Work Order ID: 71464

Item Name: Mid Tube Assembly

DRAWING NO. D3391	TITLE 412 FLOAT SKIDTUBE	REV. H	DART AEROSPACE USA, INC ENGINEERING ORDER		D.E.O. NO. D3391-H-1	SHEET NO. SHEET 1 OF 1	SCALE NTS
DRAWN <i>UP</i>	CHECKED <i>h</i>	MFG. APPR. <i>AA</i>	APPROVED <i>MP</i>		DE APPR. <i>MP</i>		
DATE 09.09.23	DATE 06.09.24	DATE 09/09/25	DATE 09/09/30		DATE 09/09/30

LPS-3 IS NO LONGER USED DURING ASSEMBLY OF D3391-041/-043 SKIDTUBES.

<table><tr> <td>DESIGN</td><td>PH</td><td colspan="2" rowspan="2"> DART AEROSPACE USA, INC PORT HADLOCK, WA </td></tr><tr> <td>MFG. APPR.</td><td></td><td>D3391</td><td>SHEET 1 OF 8</td></tr></table>

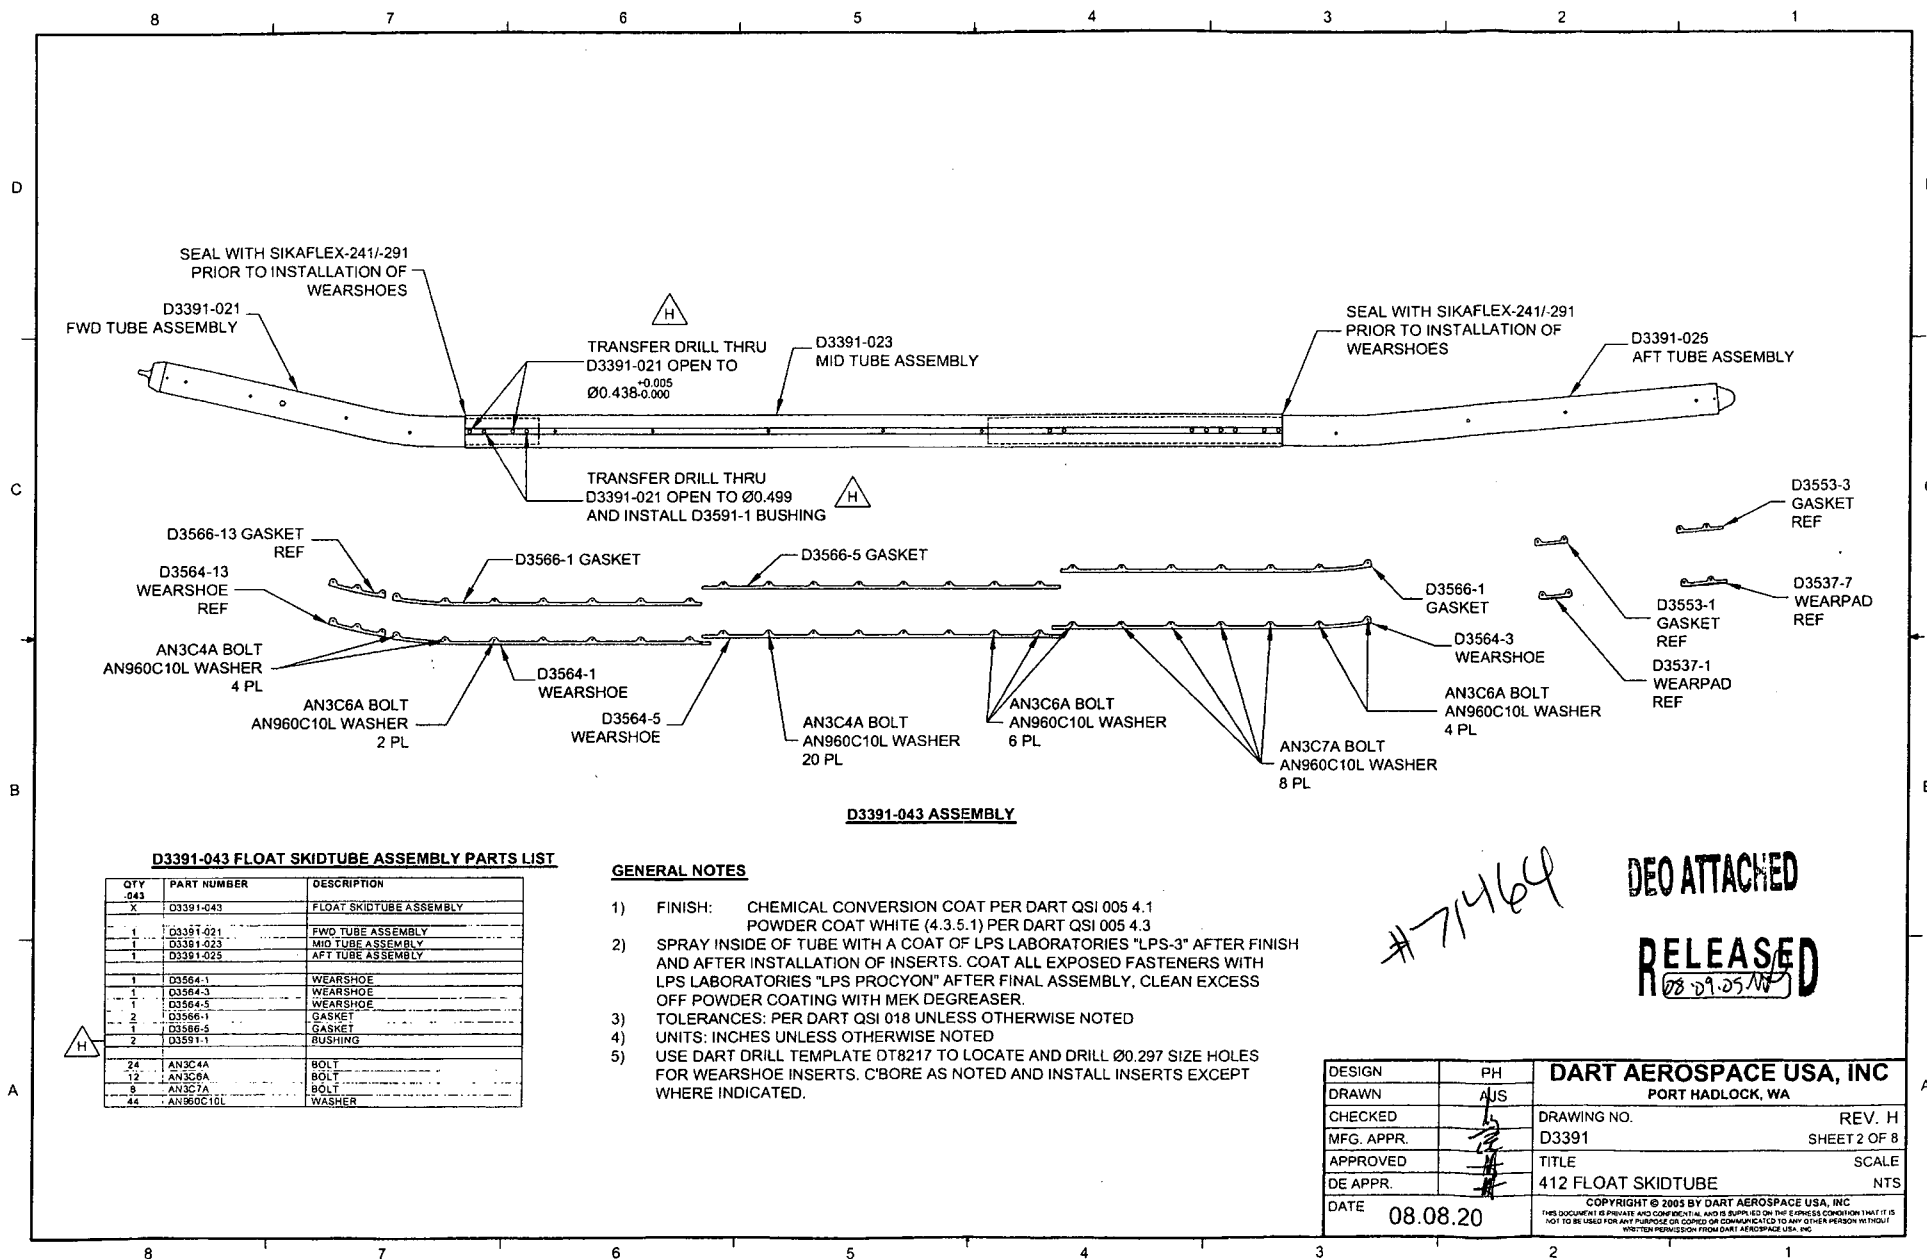
AMEND NOTE 2 OF D3391-041/-043 SKIDTUBE ASSEMBLIES (ZN A6-1, A6-2) AS FOLLOWS:

- 2) ~~SPRAY INSIDE OF TUBE WITH A COAT OF LPS LABORATORIES "LPS-3" AFTER FINISH~~
~~AND AFTER INSTALLATION OF INSERTS. COAT ALL EXPOSED FASTENERS WITH~~
 LPS LABORATORIES "LPS PROCYON" AFTER FINAL ASSEMBLY, CLEAN EXCESS
 OFF POWDER COATING WITH MEK DEGREASER.
